Facility Name: TMI-2 ISFSI Change No.: 318936
Activity Description: SPR-173, "CPP-1774 Efflorescence Sampling (ESP-032-07)", Revision 0 is being issued to document the characterization plan for non-invasive sampling of efflorescence on the exterior surfaces of the HSMs to determine chemical constituency.

1. Action: Create Revise Cancel Suspend Document: SPR-173 Rev: NEW Change #: 318936
Document Title: CPP-1774 Efflorescence Sampling (ESP-032-07)

Idaho Cleanup Project	Sampling Procedure	For Additional Info: http://EDMS	Effective Date:
<hr/> Change Number:

Figure 1.1-1
Location of the INEEL TMI-2 ISFSI

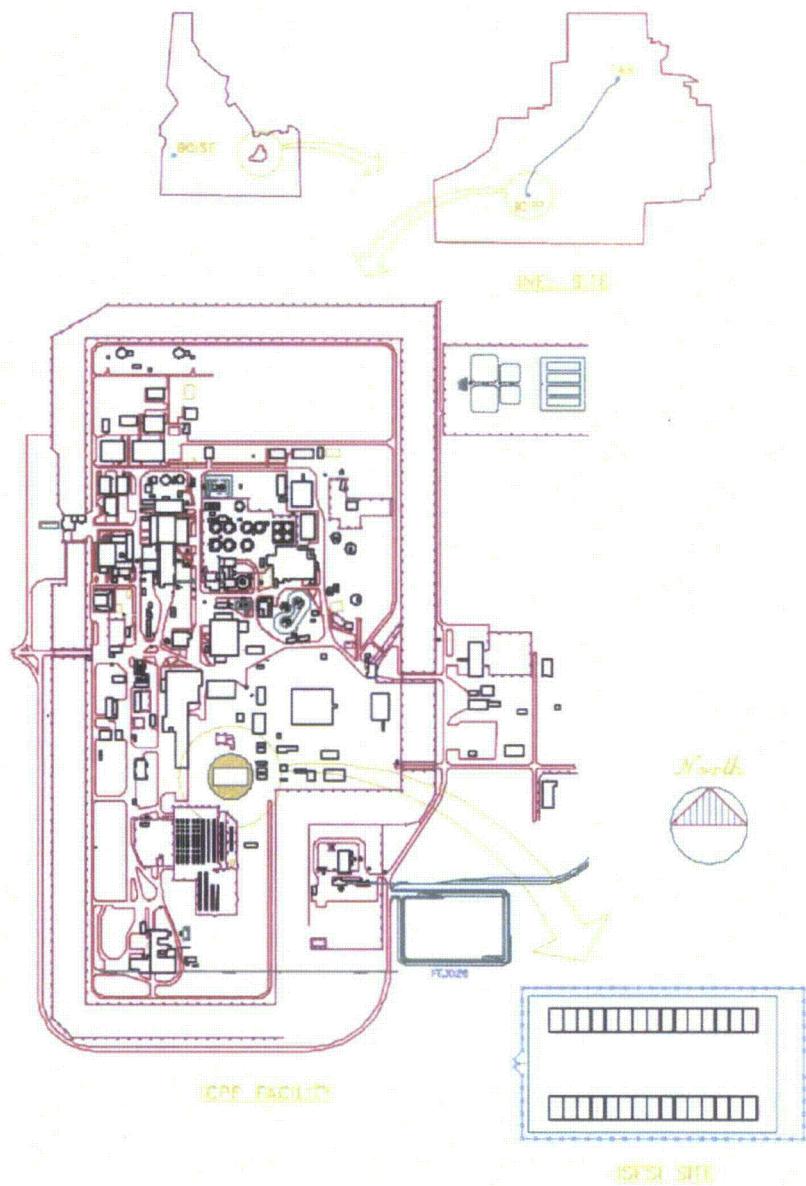
Comment 7244-23:	/icp_d/drft/DRAFT_318936_2_2.doc	Section #: General	
Can a more updated figure be used for figure 1.1-1? One without the terms ICPP, INEL, and INEEL.		Submitted by: Swenson, Kirk Barney representing QUALITY ASSURANCE on 07/31/2007	
Resolution:	Resolved By:	Acceptance Due by:	Accepted/Rejected:
Possibly. I am unaware of any current map of CPP-1774. In all of my EDMS searching, this map was the most detailed in showing where CPP-1774 is located inside the INTEC.	Andersen, Travis Rex on 08/01/2007	08/02/2007	ACCEPTED
<hr/>
